Acquisition Directorate

Research & Development Center

U.S. National Committee TC80 Technical Advisory Group FY14 Support

September 2014

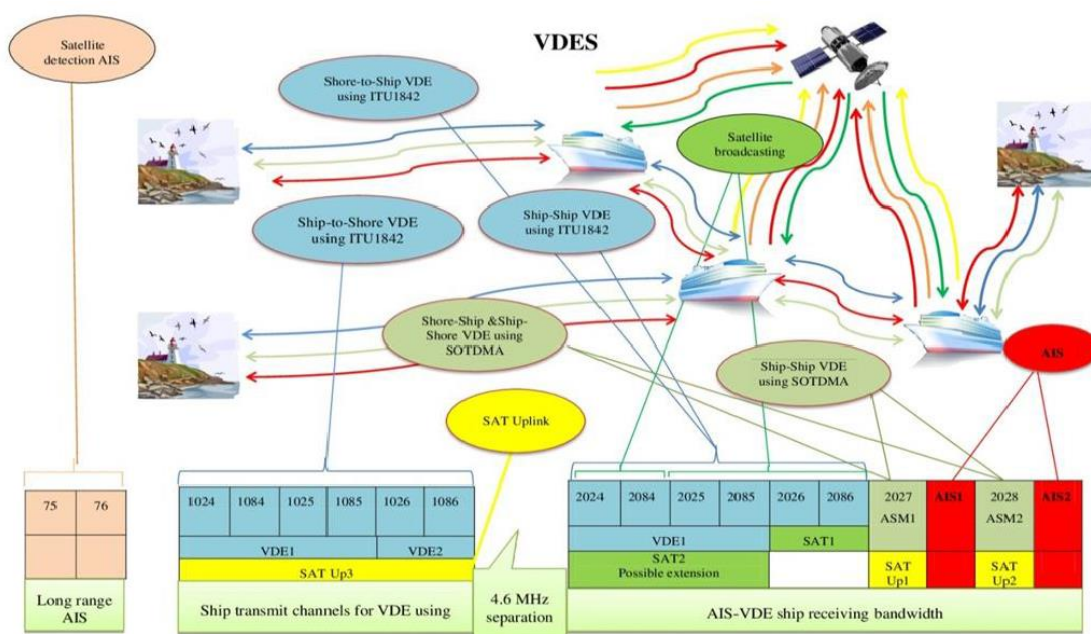
At the US National Committee Technical Advisory Group meeting, held on 30 April, it was recommended we vote against this standard because of the decision to remove the AIS base station symbol as a result of committee draft for voting (CDV) comments. Both Australia and Denmark voted to eliminate it from the draft standard. Denmark voted to eliminate it because it uses the same basic symbol as an AtoN and "it is highly questionable if an AIS Base station and its position is relevant to the navigation of vessels". Australia voted to eliminate it because "at the present time, there has been no discussion regarding the navigational significance of an AIS base station". Australia also questioned "what a mariner might do with the information presented?" Australia said it was "interested in learning more about the possible navigational significance of an AIS base station and/or an AIS repeater station, which would necessitate the inclusion of the symbol in the IEC 62288 standard." The recently approved radar standard IEC 62388 Ed2 however does require the radar to handle and display AIS messages including Message 4 (AIS base station) for AIS targets.

Mr. Jorge Arroyo (CG-NAV) indicated that there is navigational significance in displaying the AIS base station symbol on a navigation display. Base stations can be used to broadcast ATON reports, VTS targets (see §5.5.4.1 of the standard), traffic signals, mandatory routes, clearances, waterway closures, safety notices, etc. The only way to truly ascertain whether you are in range of these broadcasts is by also seeing the base station on the display (AIS MSG 4). Portraying base stations will also reduce unnecessary outage reports. If operators don't see a base station (symbol), then they don't have an outage, they would know that they are just out of range. If they see a base station, but not an ATON or other expected pertinent navigation information, then an outage likely exists - which should be reported. There is no other effective way of ascertaining this other than needlessly asking the Coast Guard whether they were broadcasting the information.

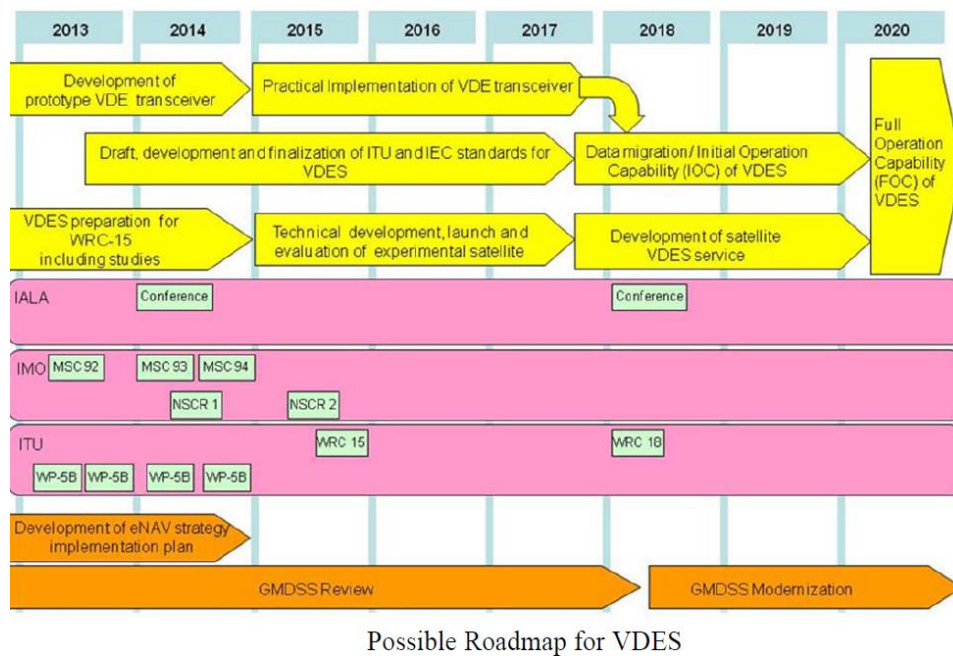
VDES use of a satellite downlink will require a spectrum allocation amendment to the ITU-R Radio Regulations, possible only at an ITU-R World Radio Conference. Since the bands are shared by other non-maritime users it will also require an amendment to Appendix 5 Annex

1, Coordination thresholds for sharing between mobile satellite systems (space to earth) and terrestrial services in the same frequency bands. WP5B is in fact proposing such amendments to be considered at WRC-15. WP5B meeting in May 2014 after consulting with WP5A (mobile) and WP5C (fixed) decided to recommend a power flux density (PFD) mask on VDES satellite downlink transmissions be limited to the following in order to protect terrestrial (e.g. land mobile) systems operating in the same frequency band:

$$PFD(\theta^{\circ})_{(dBW/(m^2 \cdot 4 \text{ kHz}))} = \begin{cases} -149 + 0.16 * \theta^{\circ} & 0^{\circ} \leq \theta < 45^{\circ}; \\ -142 + 0.53 * (\theta^{\circ} - 45^{\circ}) & 45^{\circ} \leq \theta < 60^{\circ}; \\ -134 + 0.1 * (\theta^{\circ} - 60^{\circ}) & 60^{\circ} \leq \theta \leq 90^{\circ}. \end{cases}$$

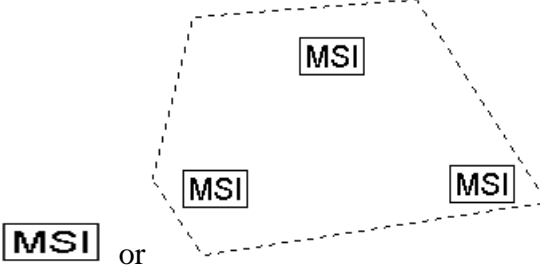
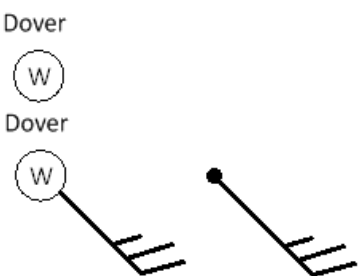
Despite IMO SN.1/Circ.243/Rev.1:2014 not being listed as a normative reference in IEC 62288 Ed.2, all of the AtoN symbols included in the Circular are included in the IEC standard. IEC 62288 Ed.2 appears compliant with the 2014 edition of the Circular. Nevertheless, the IEC standard includes several symbols not included in the Circular.

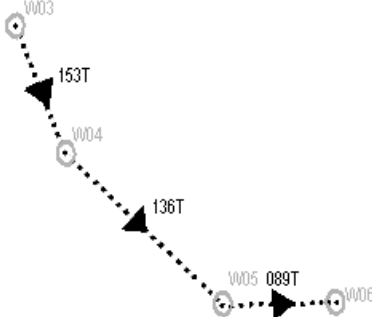
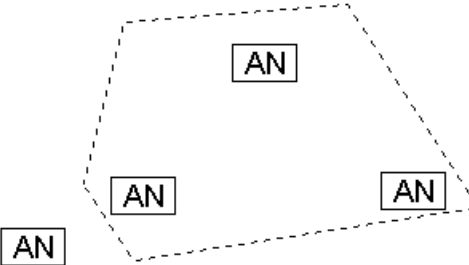
The IMO Circular defines POB (person overboard), but makes no use of it in its defined symbology. On the other hand, the Circular does not define MOB (man overboard), yet uses and defines, as an example, it in association with an Event Mark. IEC 62288 Ed.2 makes no mention of POB, uses the term MOB in

association with both an Event Mark and an AIS SART, but does not include its definition in Table B-1. Since IMO recognizes a SART only for locating a vessel or person in distress and not for alerting a ship to a distress situation, the IEC standard required the display color of the SART symbol to be blue, the same color used by aids to navigation, meteorological, tidal, and signal station symbology. The IEC standard allows the user to filter the presentation of the AIS SART
